London Borough of Redbridge Design Review Panel

Report of Formal Review Meeting: 720 High Road

Former 'Homebase' Retail Warehouse, 706-720 High Road, Goodmayes, IG3 8RS

706 – 720 High Road, Goodmayes, Ilford, IG3 8RS
Response to consultee comments relating to application 0680/21

GROUND FLOOR LEVEL CYCLE STORAGE

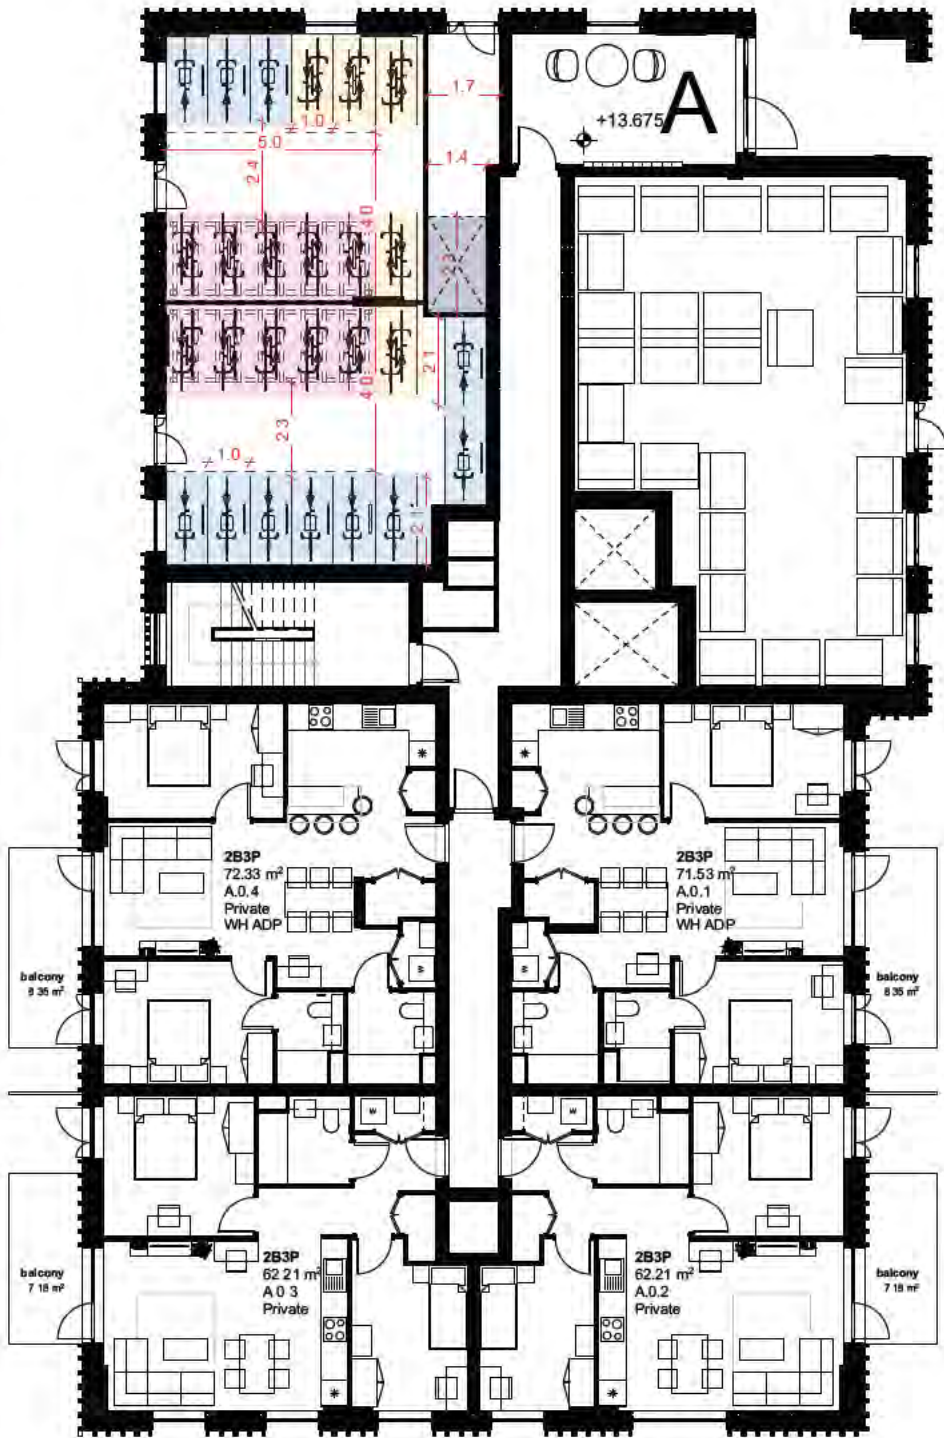
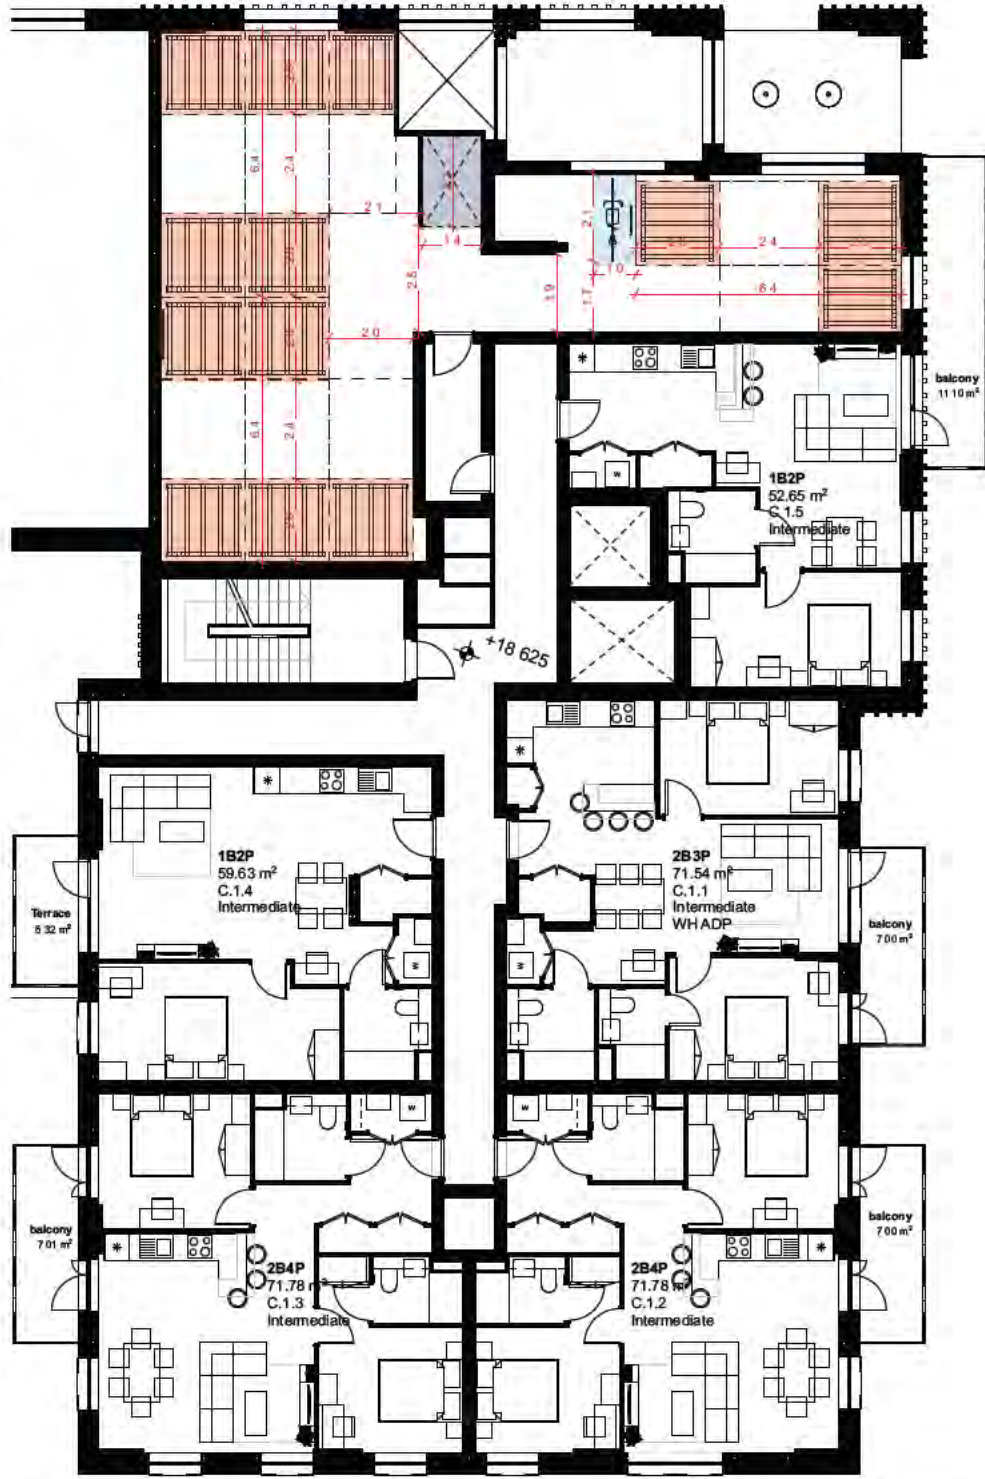
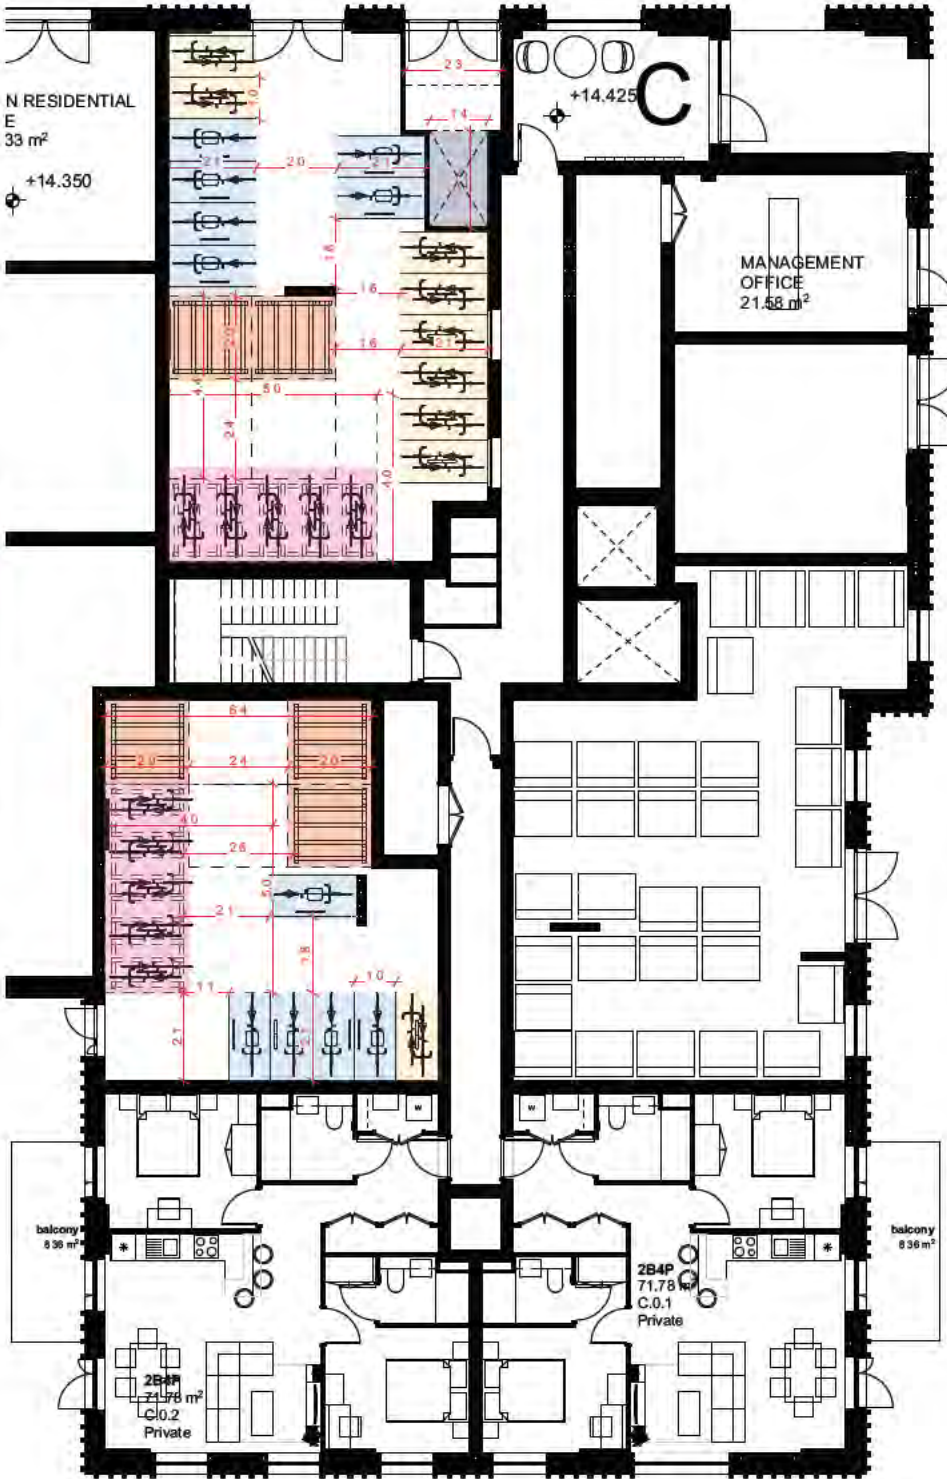
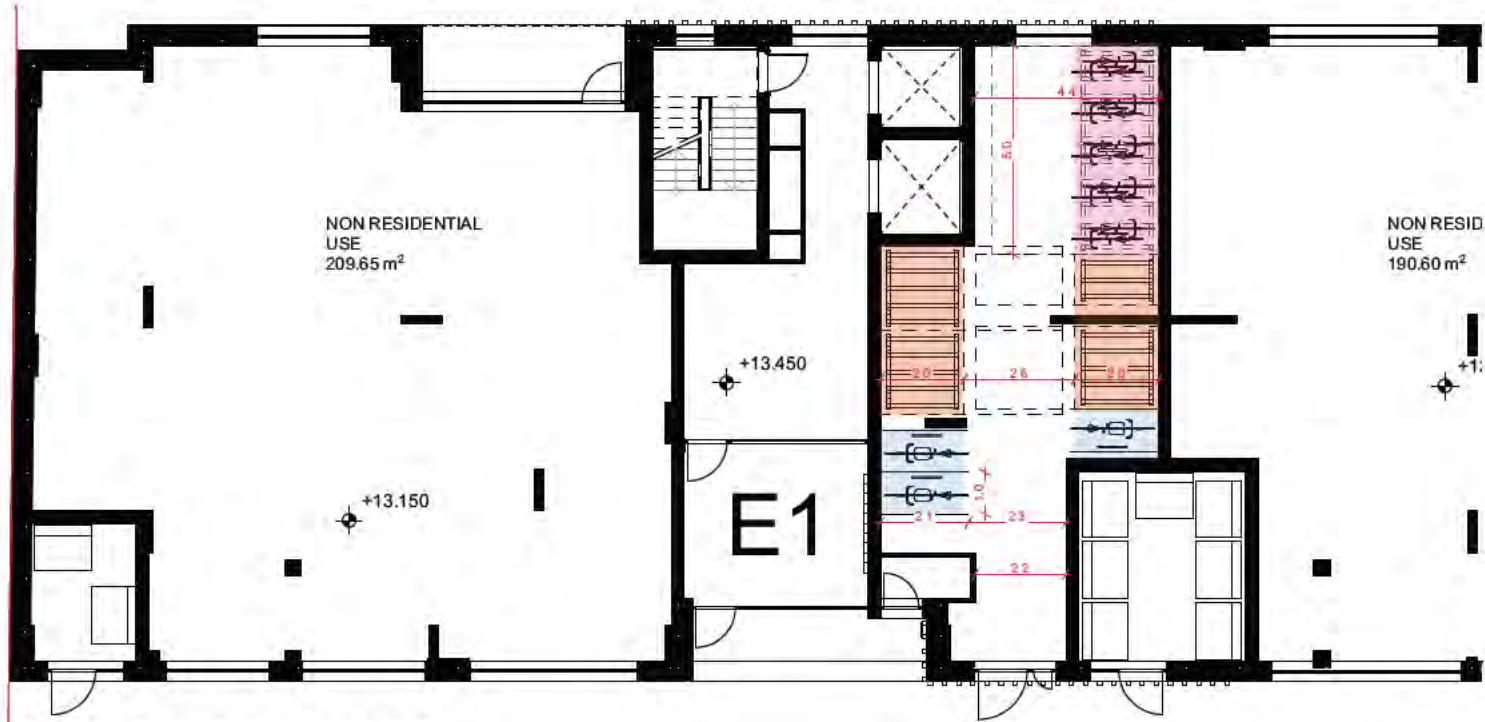
1. Clearer, more detailed plans of cycle storage. Until TfL has this we are unable to confirm compliance with LP T5 and its design requirements.
2. Mode share analysis re-visit to address concerns including too-low cycle share and scrutiny of apportionment of rail and underground vs bus trip generation – considering the latter mode can be used more conveniently than the more distant stations I am surprised it is not higher. Only when agreement on these points has been reached can TfL comment on what/whether contribution level to public transport is appropriate.

Whilst the quantum of short and long stay cycle parking complies with Policy T5 of the London Plan, the arrangements do not appear to meet the London Cycle Design Standards (LCDS) as also required by this policy. Given the development is to be car free other than the outset provision for disabled people it is essential that cycle parking for disabled people is exemplary and at least the minimum policy requirements are met for all others. Clearer, more detailed drawings are required pre-determination and revisions are likely to be needed.

PODIUM LOCATION OPTIONS

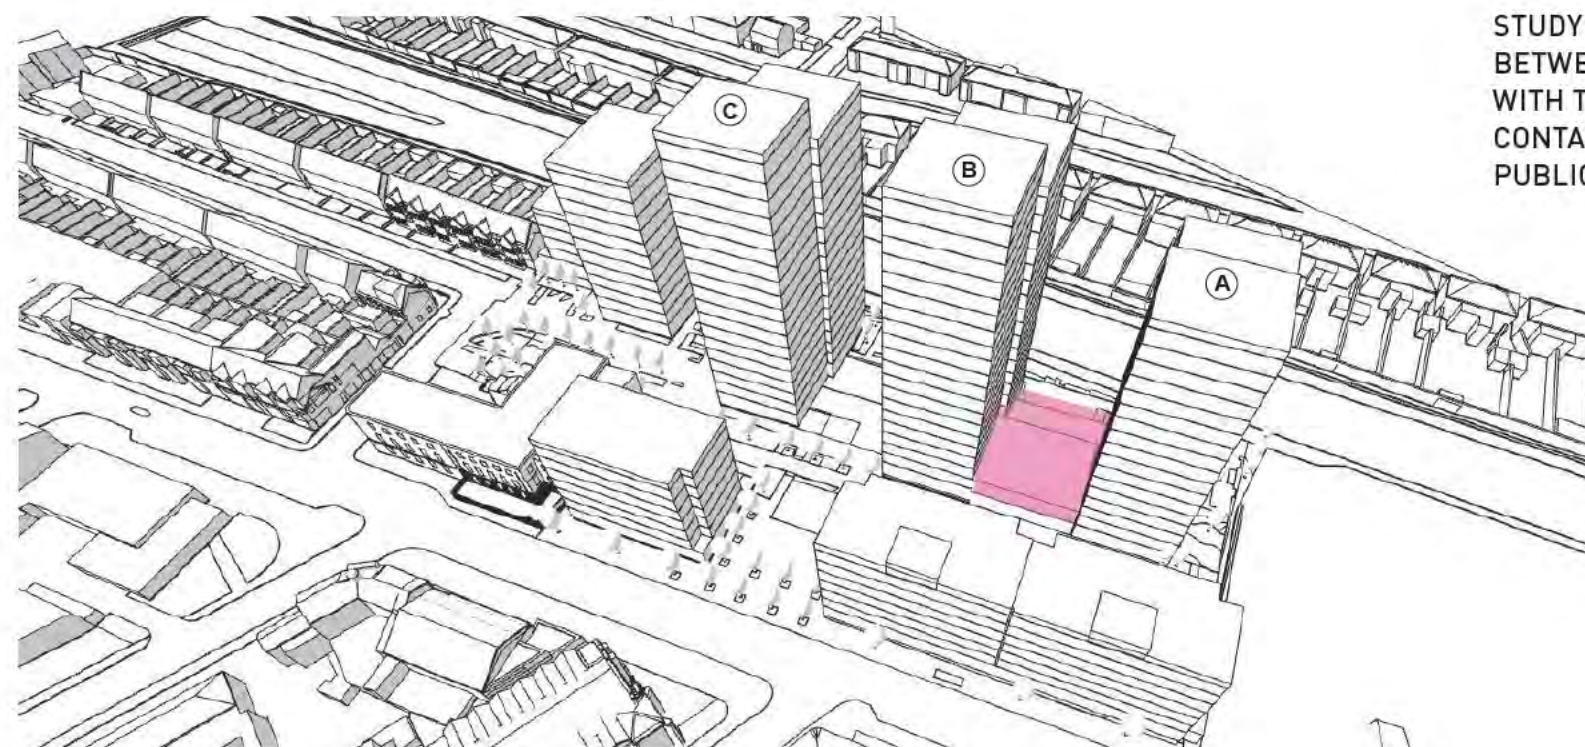
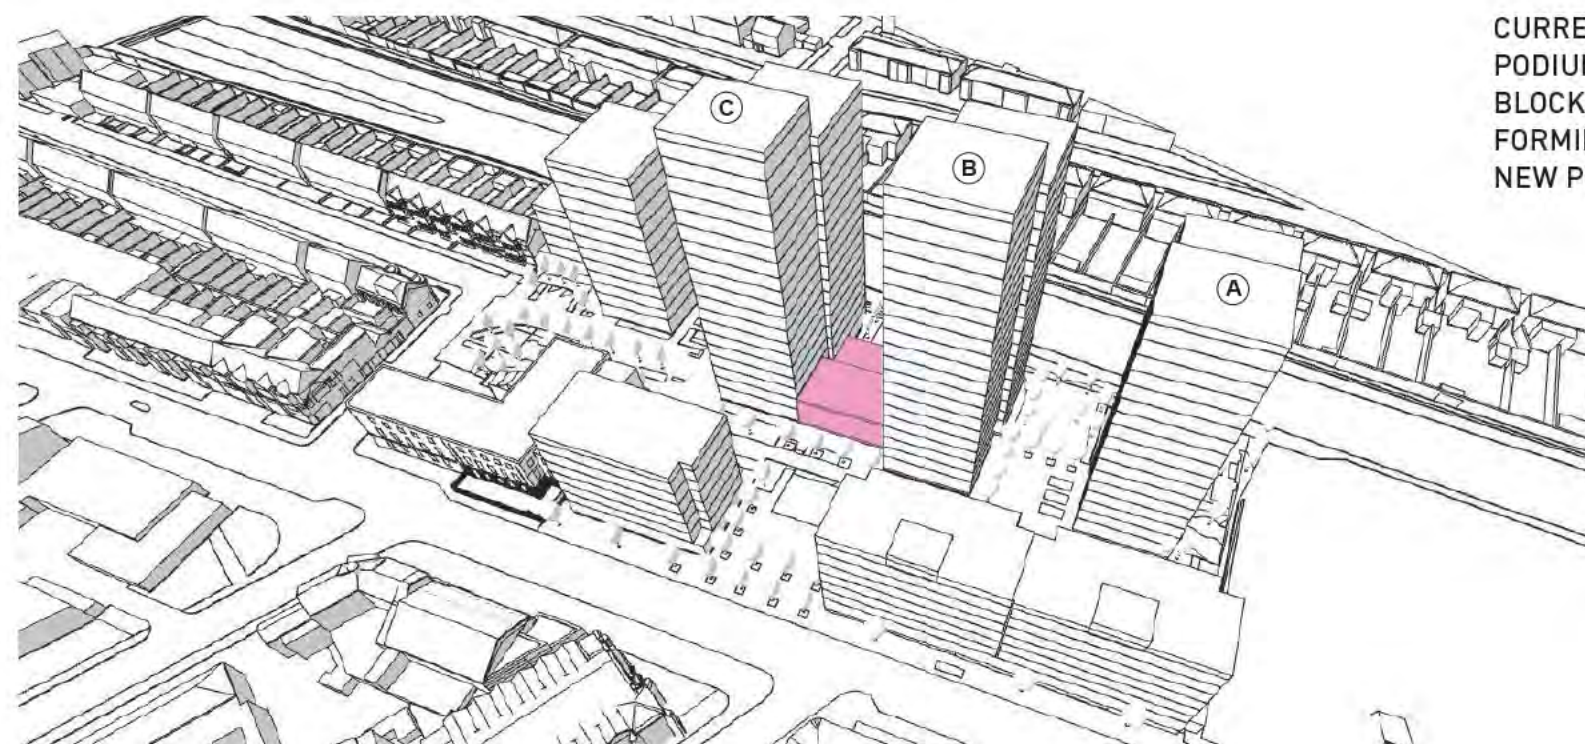
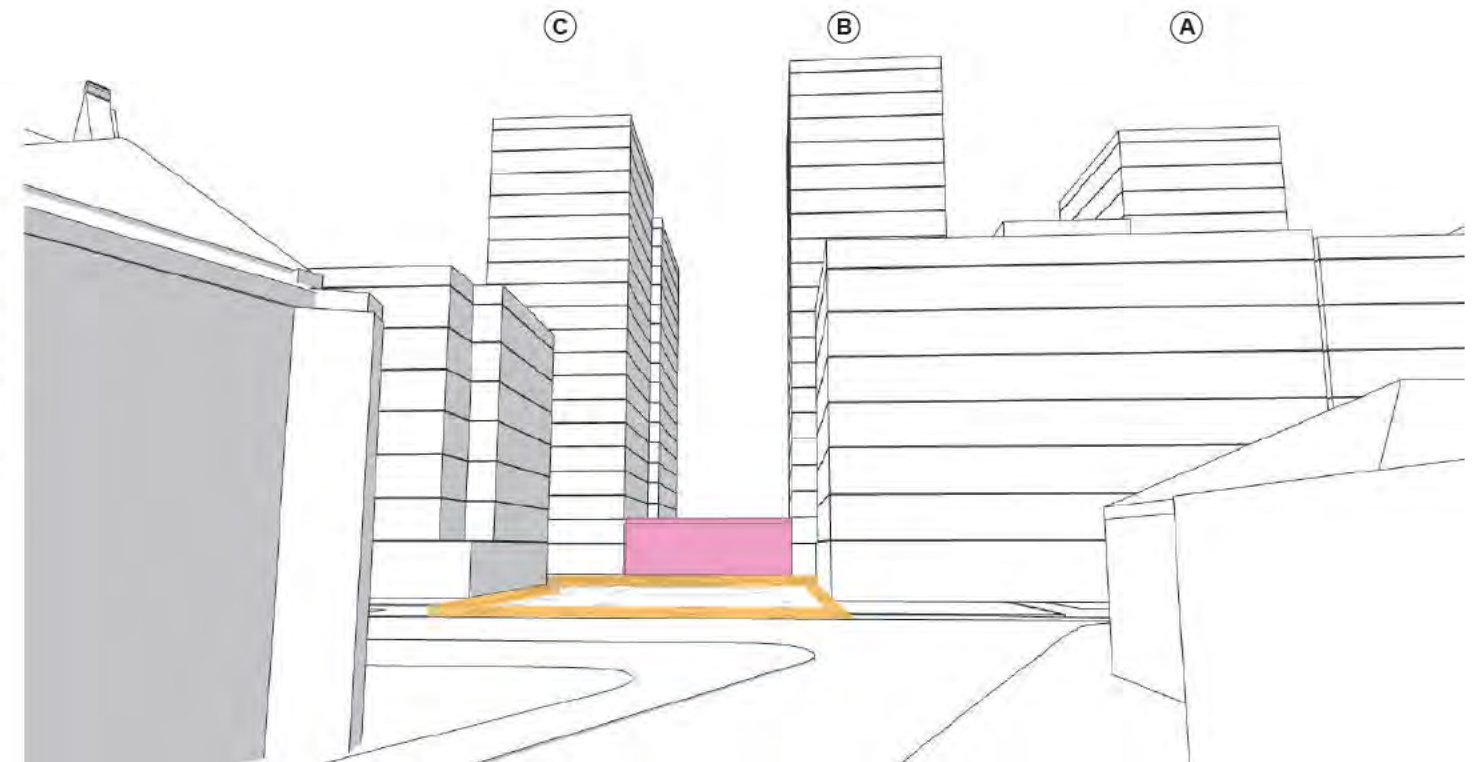
- The design team should make more use of the square to add clarity to how people move around the site. Traditionally squares are located where there is a change of direction in movement. In its current location and form, the square does not sit entirely comfortably in the urban composition although the applicant has tested alternative locations and has concluded this is their preferred option.

The adjacent diagrams indicate the proposed location of the podium (below) and the alternative approach referenced by the GLA (above). The podium location was tested at various times throughout the design process with the proposed location between Blocks B and C providing the preferred overall location for a number of reasons further described further in the following pages.

CURRENT PROPOSAL WITH PODIUM LOCATED BETWEEN BLOCKS B AND C IMPORTANTLY FORMING CONTAINMENT TO THE NEW PUBLIC SQUARE

CURRENT AND PREFERRED PROPOSAL WITH PODIUM LOCATED BETWEEN BLOCKS B AND C FORMING A BACKDROP TO THE NEW PUBLIC SQUARE
